**ADDENDUM #1
NCDOT TIP: EB-5014
LOVILLS CREEK AND ARARAT RIVER GREENWAY – MOUNT AIRY, NC**

ISSUED DECEMBER 11, 2014

LOVILLS CREEK AND
ARARAT RIVER GREENWAY
WORTH STREET TO THARINGTON PARK

LOVILLS CREEK BRIDGE END BENT 2

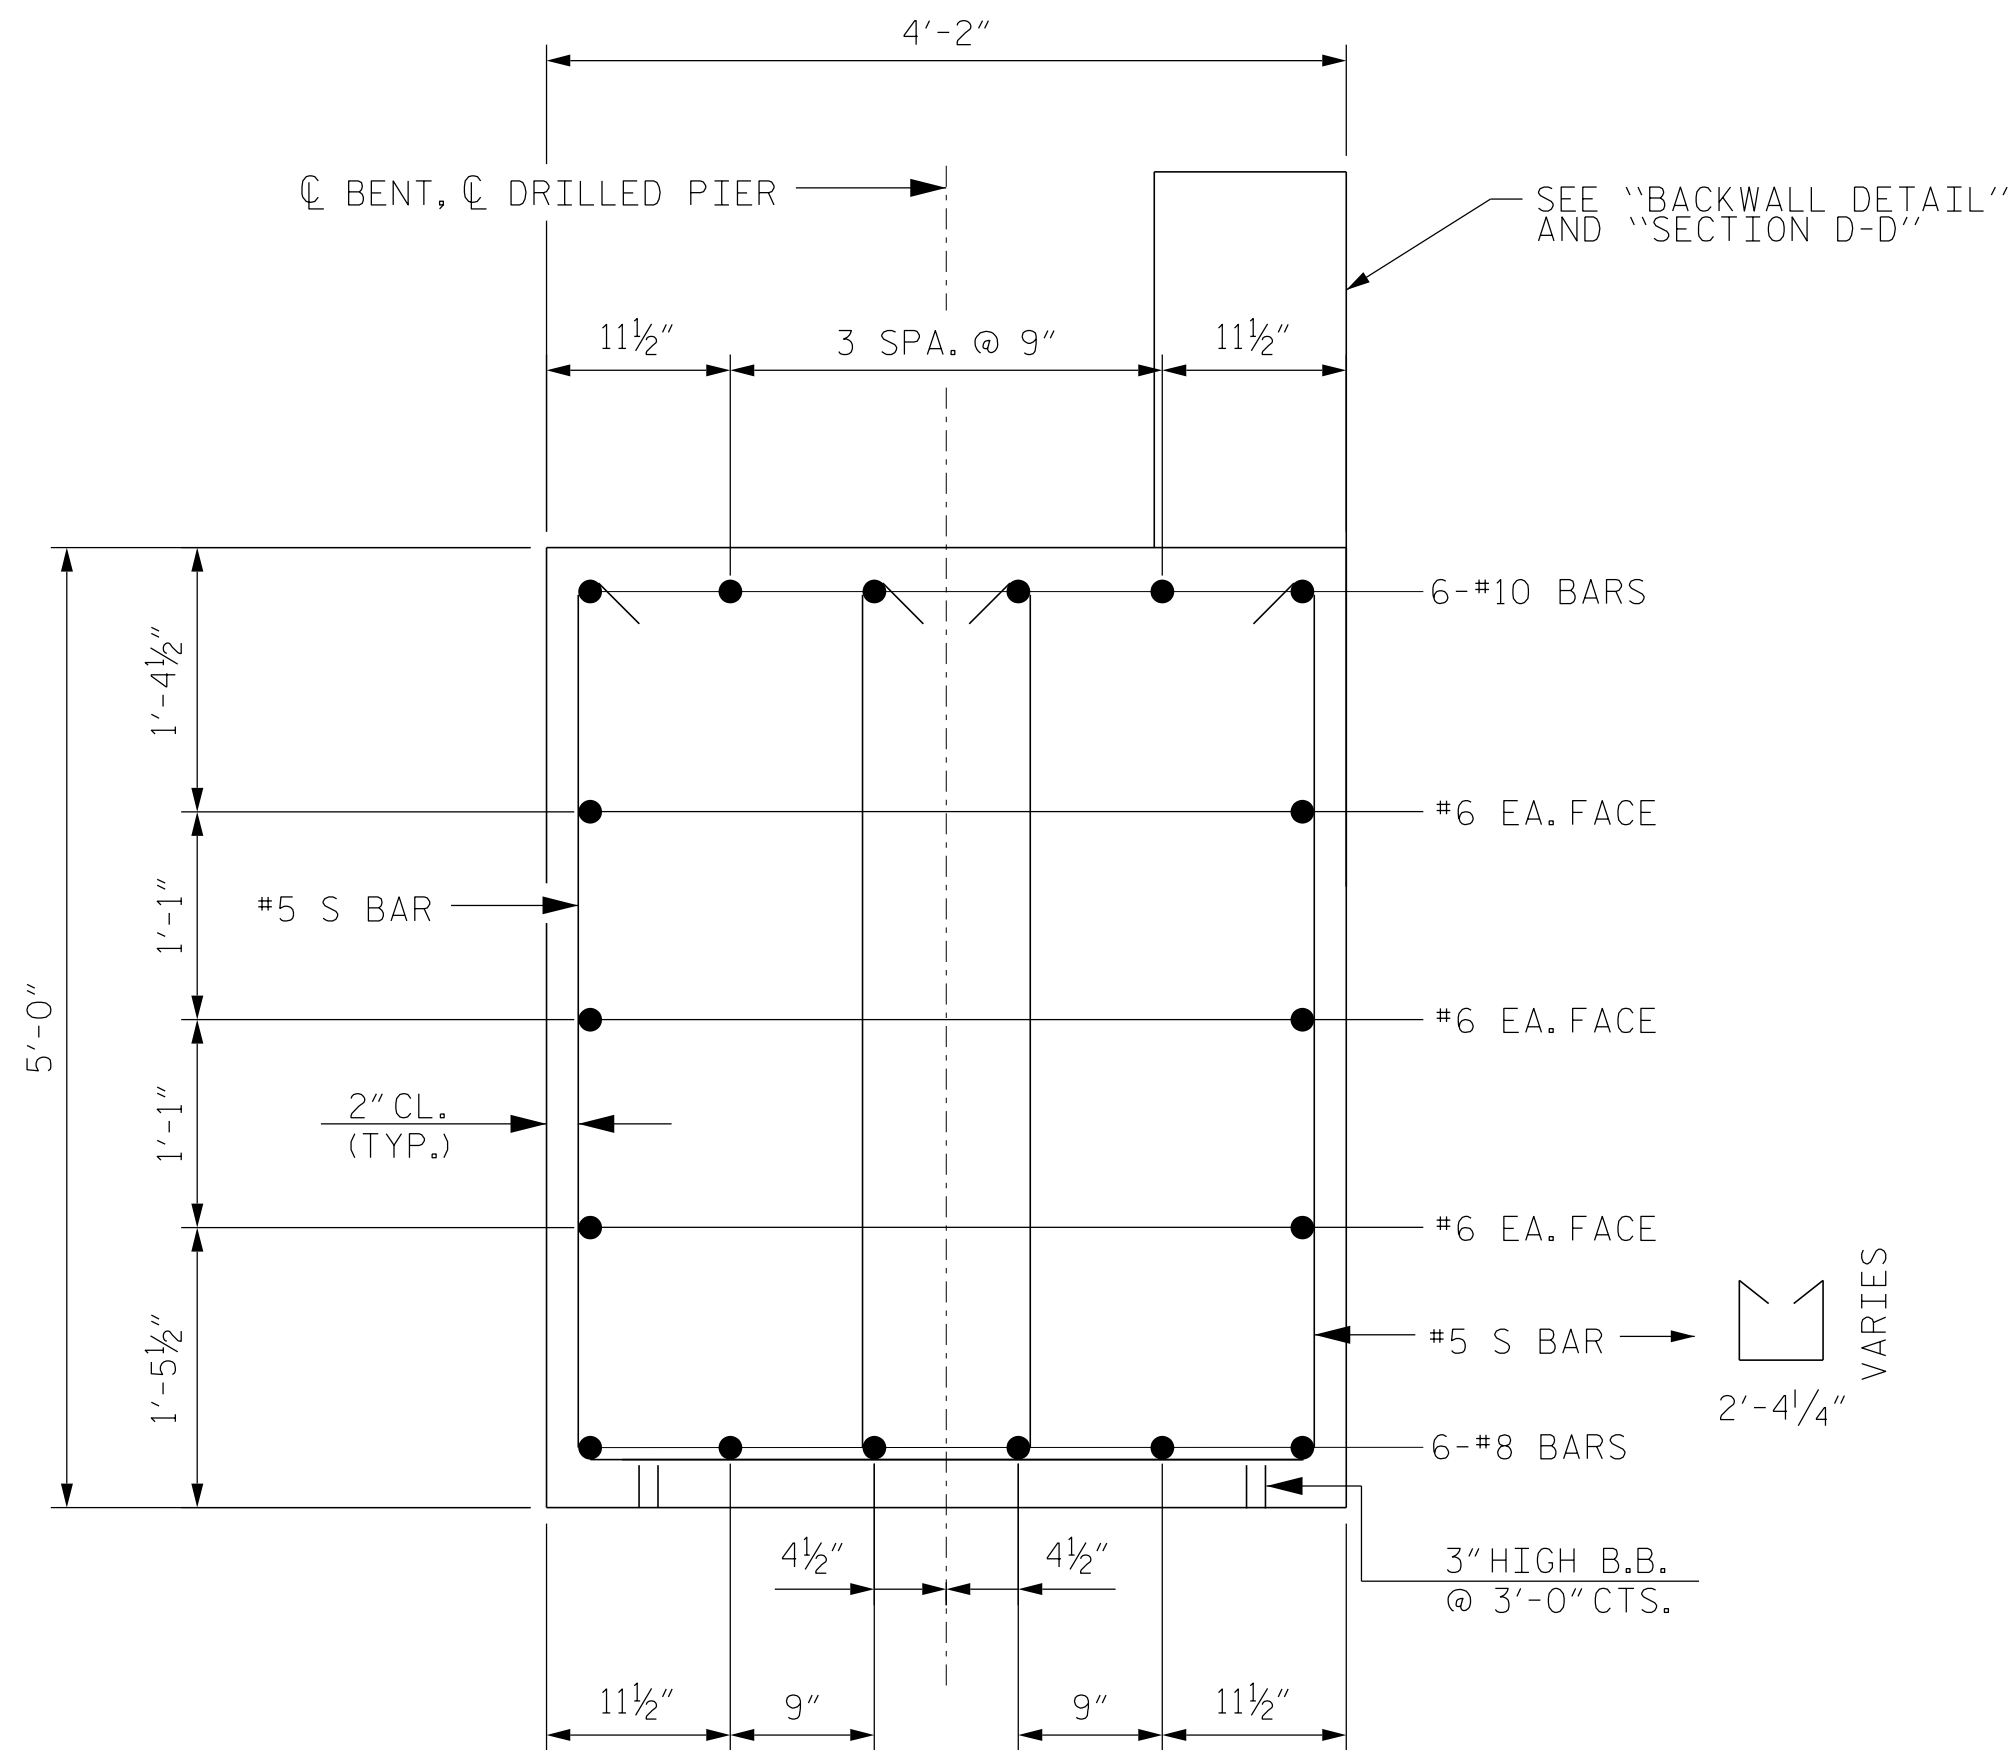
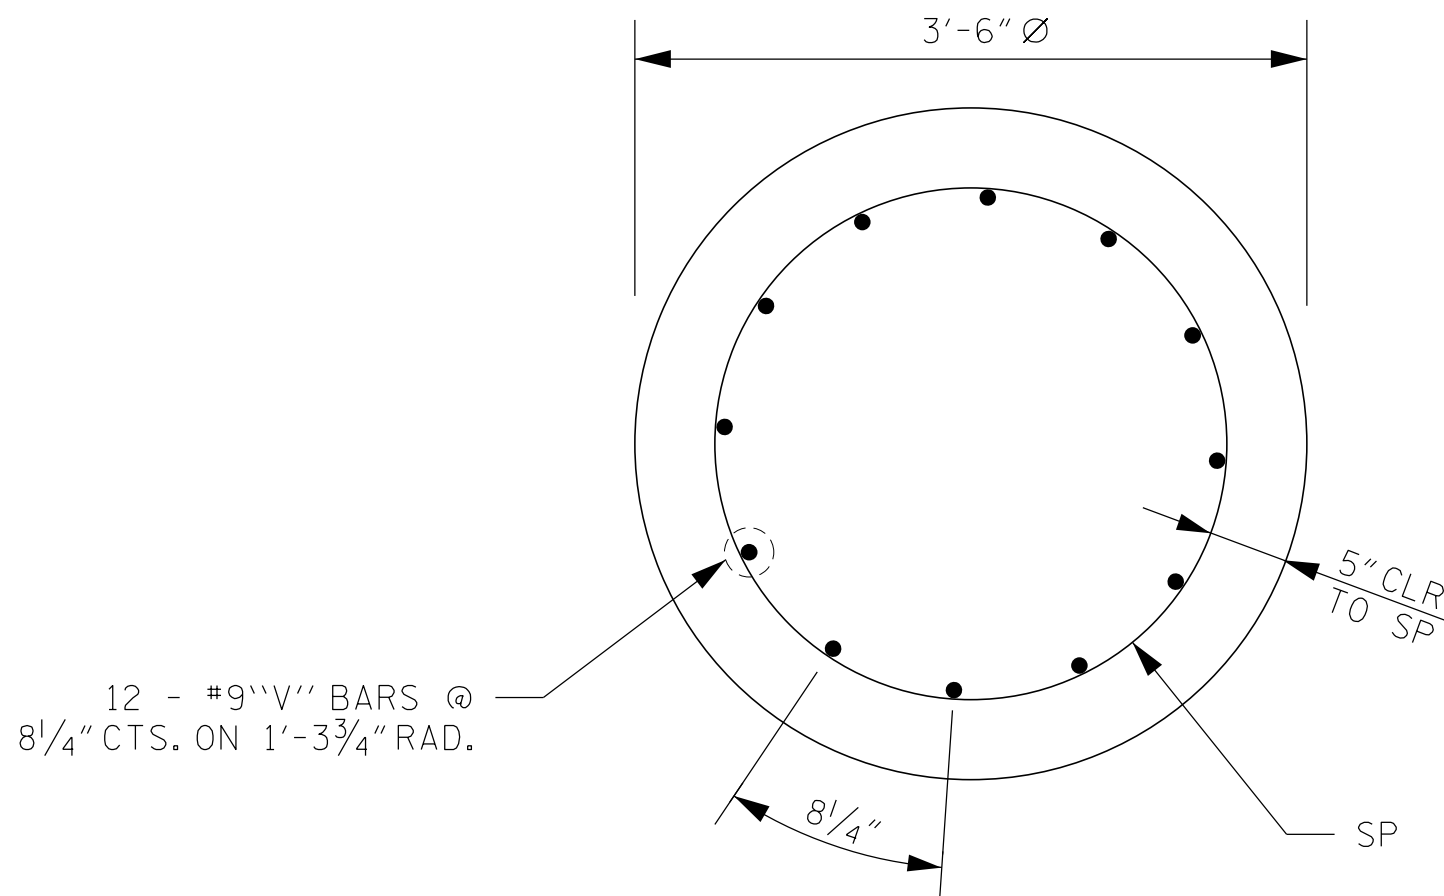
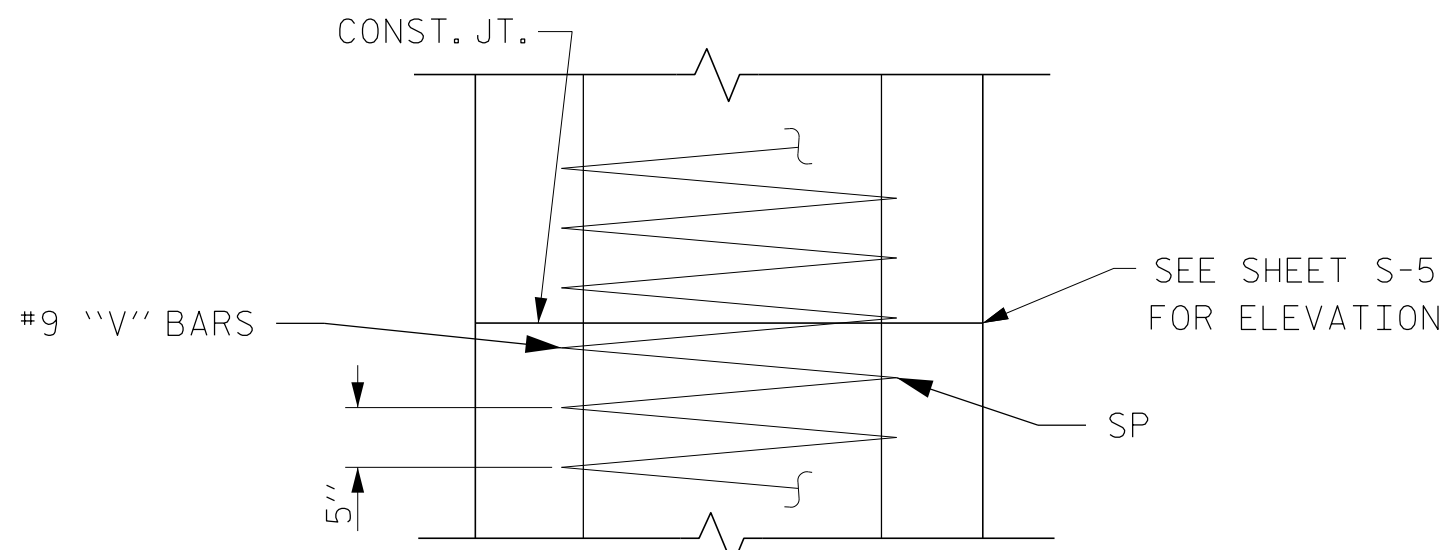
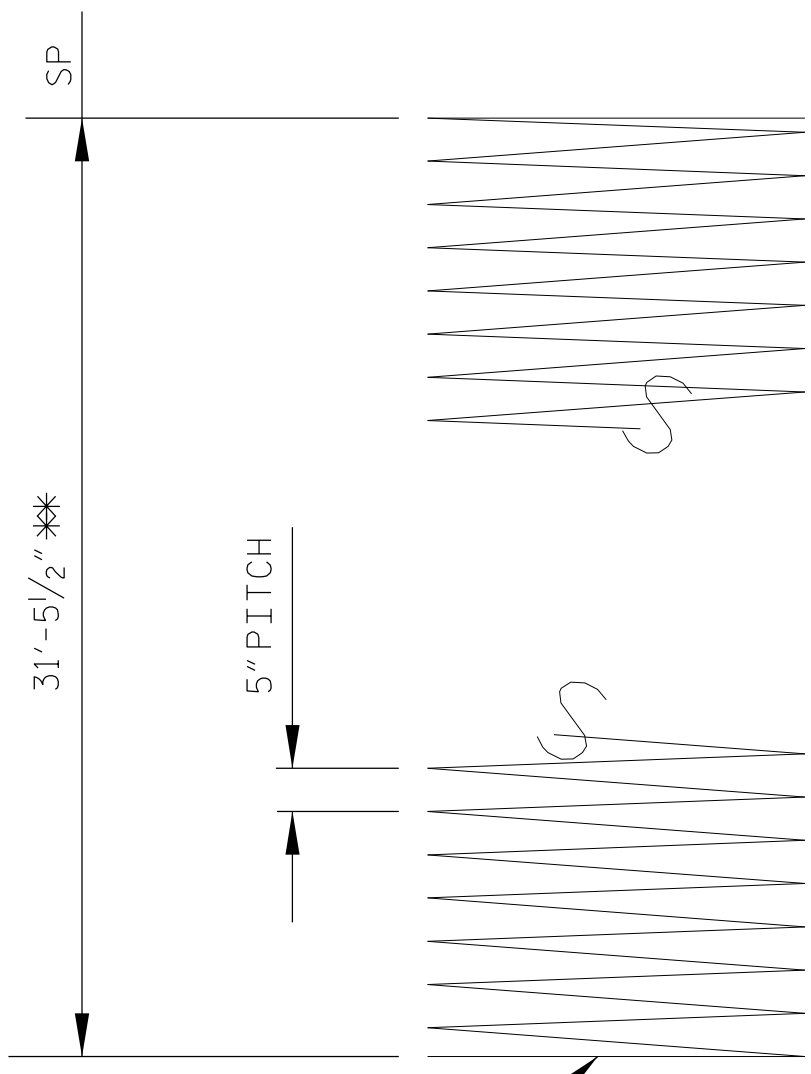
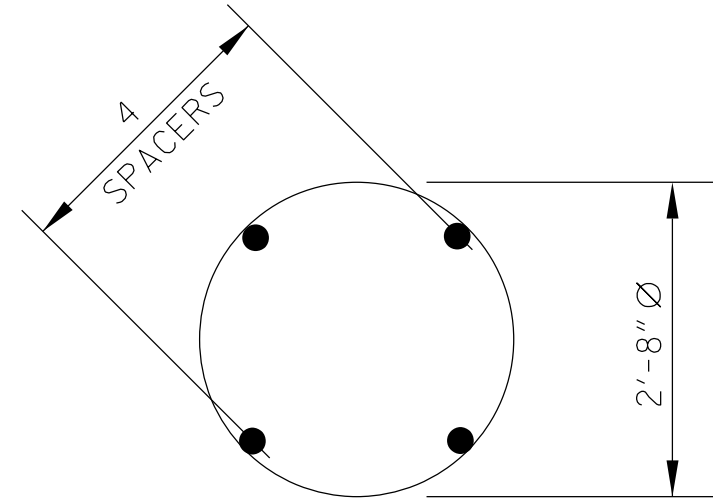
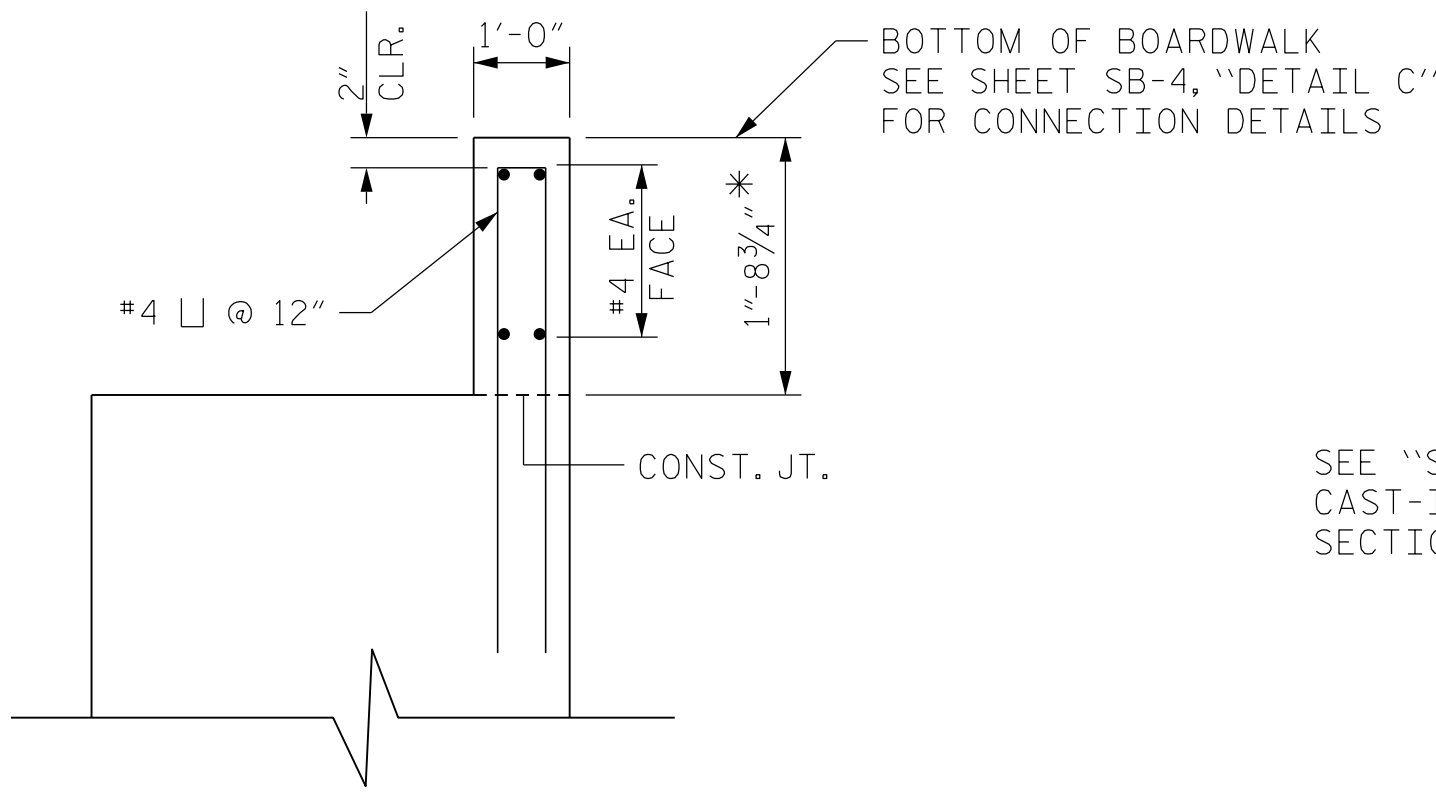
- Typical section limits on sheet 2 have been clarified.
- Plan sheets S1, S3, S4, S5, S6, and SB-1 have been modified to reflect final NCDOT review comments.

1 12/10/2014 ADDED OPTIONAL CONSTRUCTION JOINT

THE LOCATION OF THE CONSTRUCTION JOINT IN THE DRILLED PIER IS BASED ON AN APPROXIMATE GROUND LINE ELEVATION. IF THE CONSTRUCTION JOINT IS ABOVE THE ACTUAL GROUND ELEVATION, THE CONTRACTOR SHALL PLACE THE CONSTRUCTION JOINT 1 FOOT BELOW THE GROUND LINE.

TYPICAL BOARDWALK DETAILS

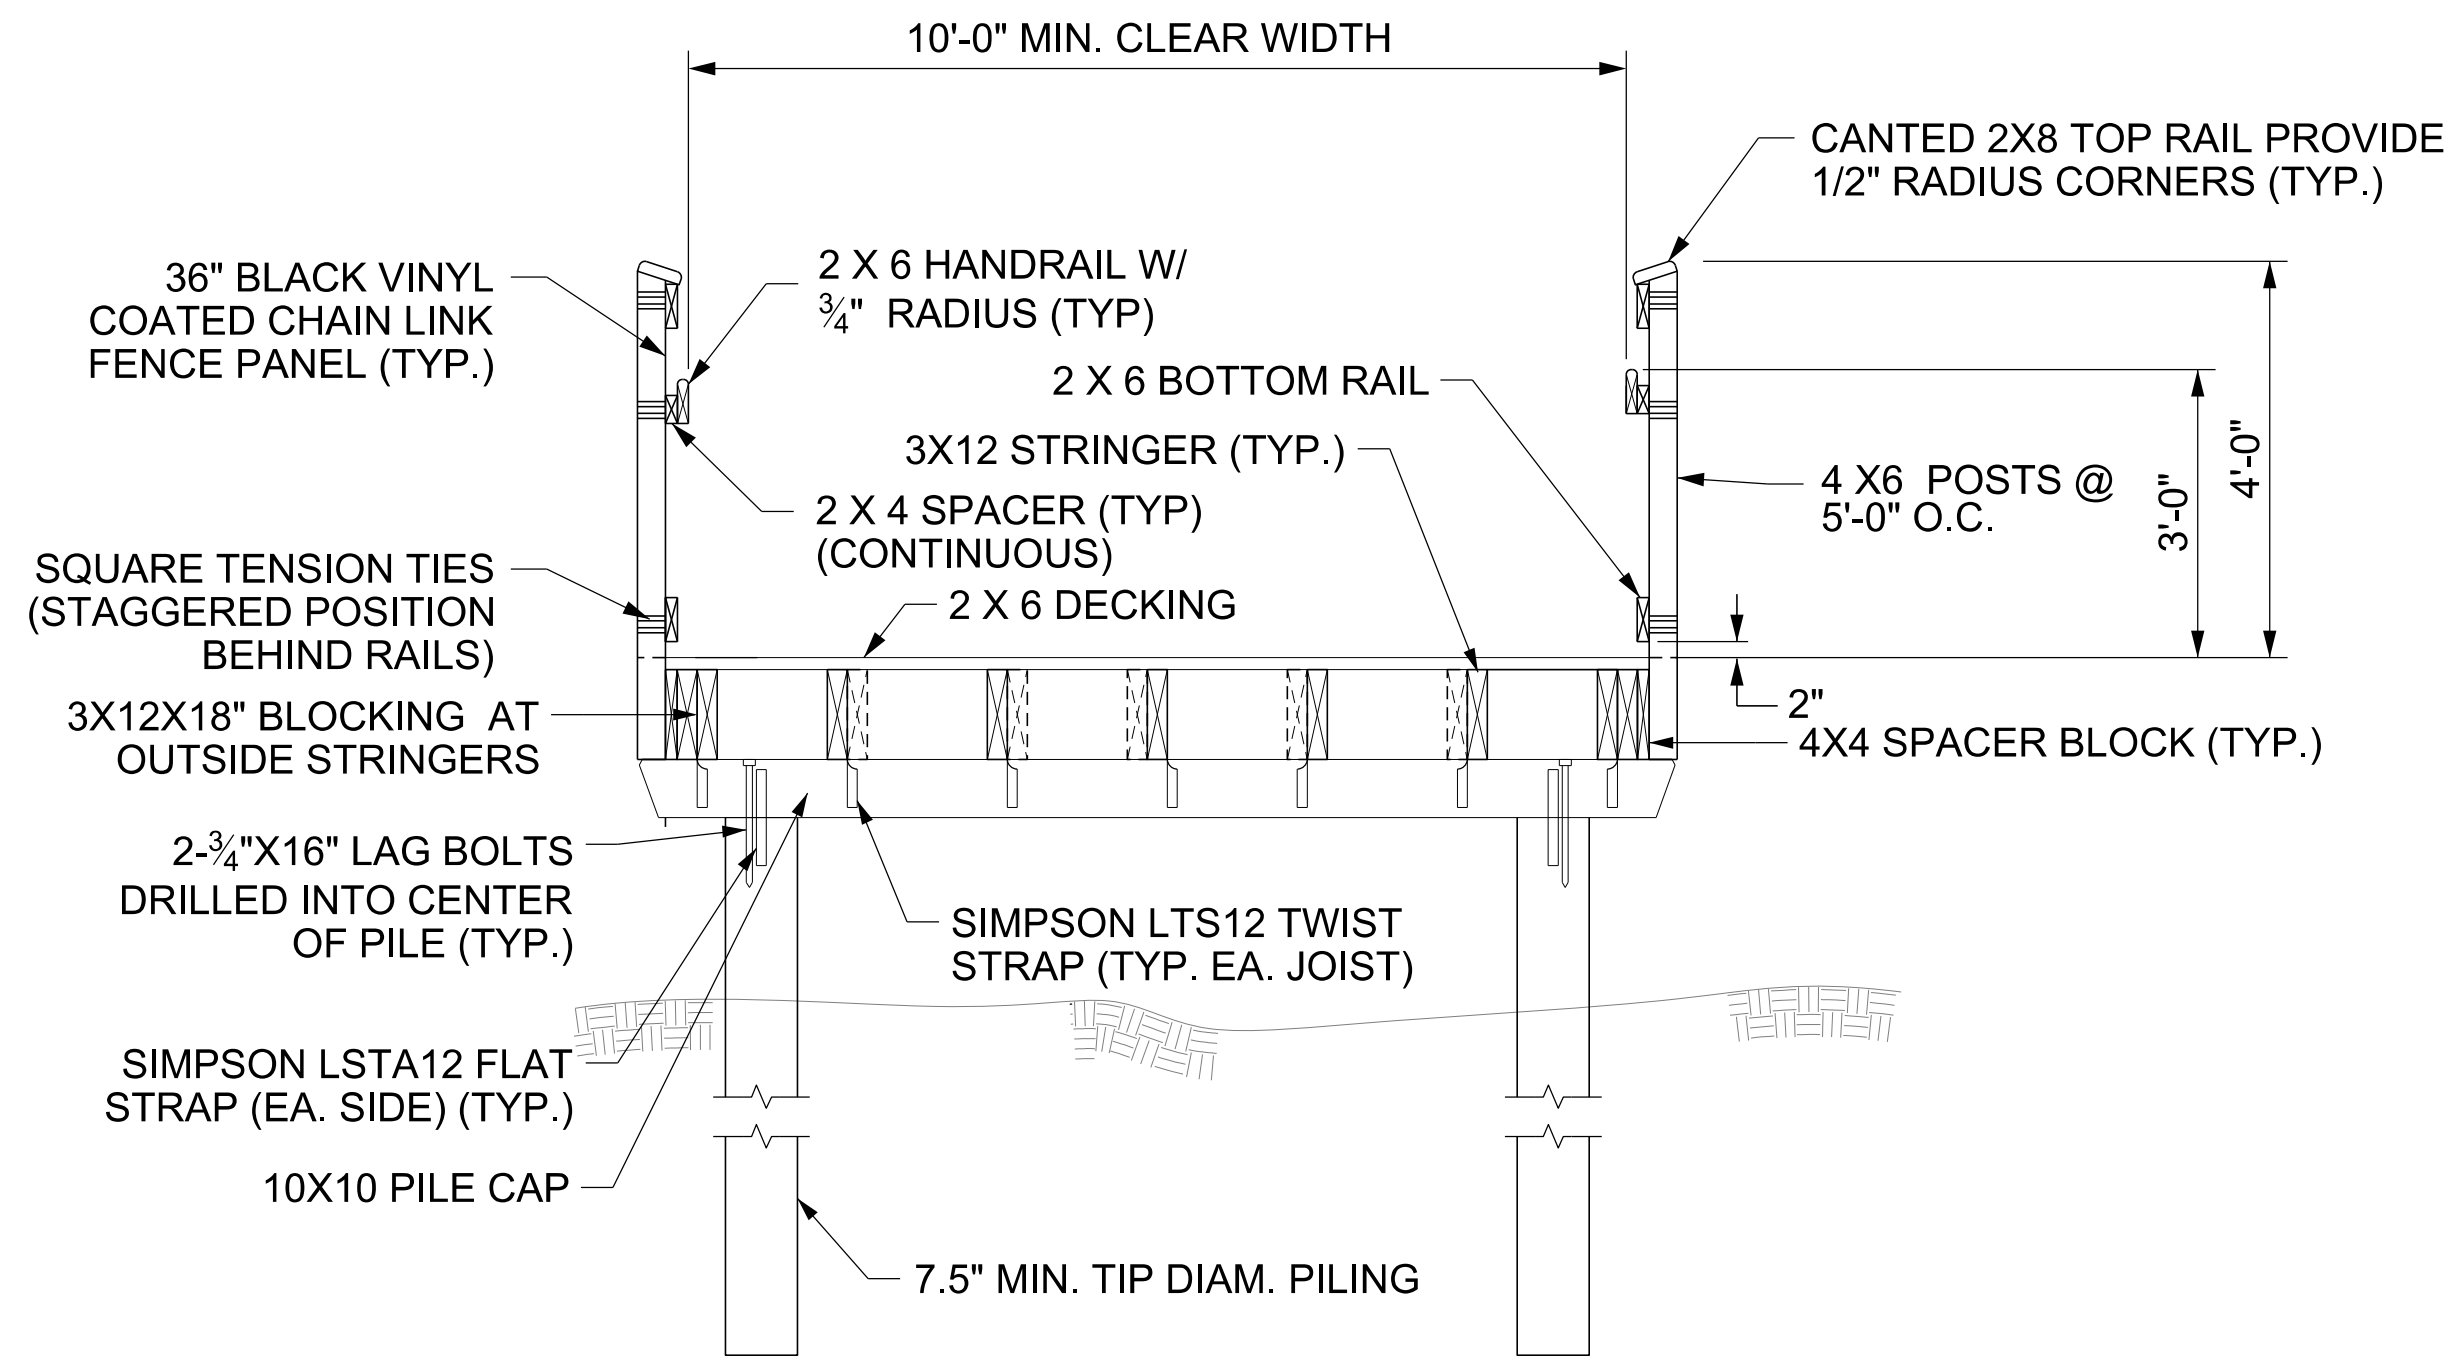
ADDED NOTE
